ADMINISTRATIVE AMENDMENT

GROWLER USA
RESTAURANT & BREWPUB
1401 WOODWARD RD SE
ALBUQUERQUE, NEW MEXICO

REVISIONS	DATE	BY	DESCRIPTION
1	07-08-20	ACCD	DRIVE-THRU

Sheet Title:
Architectural Site Plan
OPTION 3

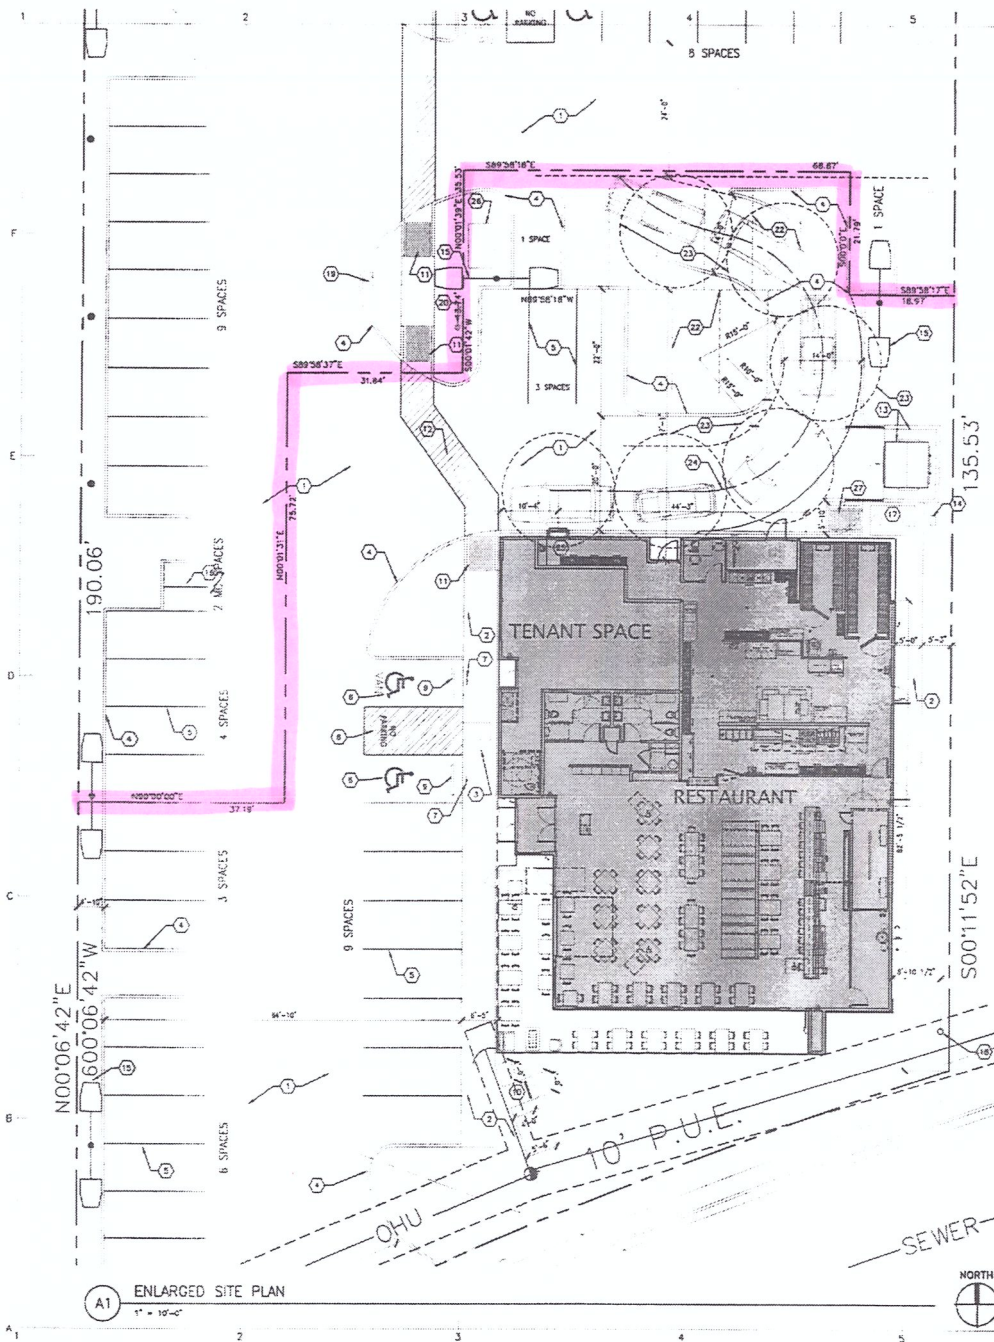
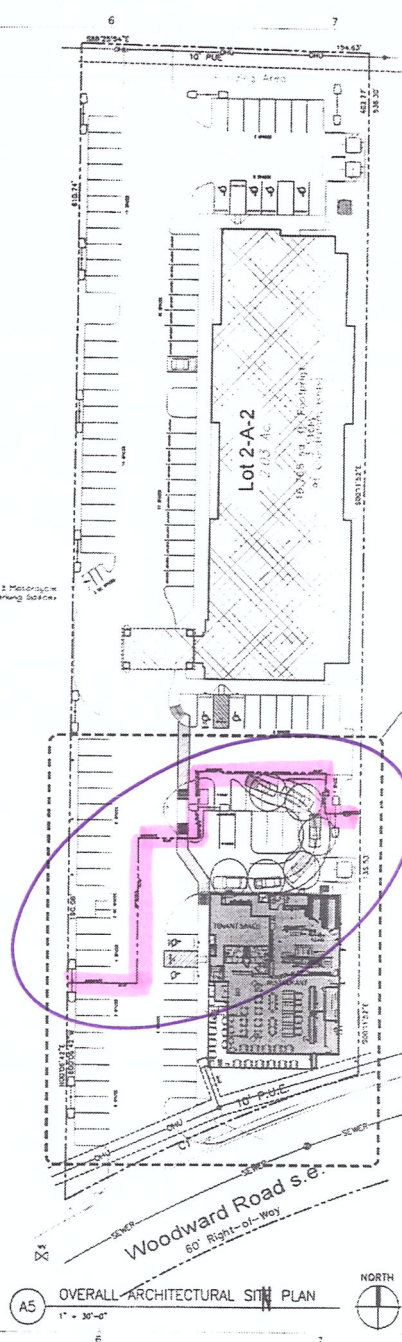
23. DASHED CIRCLE LINE INDICATES 20' CAR STACKING SPACE
 24. DASHED LINE INDICATES CENTERLINE OF NEW 14' DRIVE-THRU DRIVE LANE
 25. NEW DRIVE-THRU WINDOW

26. EXISTING ELECTRICAL TRANSFORMER TO REMAIN
 27. NEW ADA RAMP

REVISED PROJECT DATA
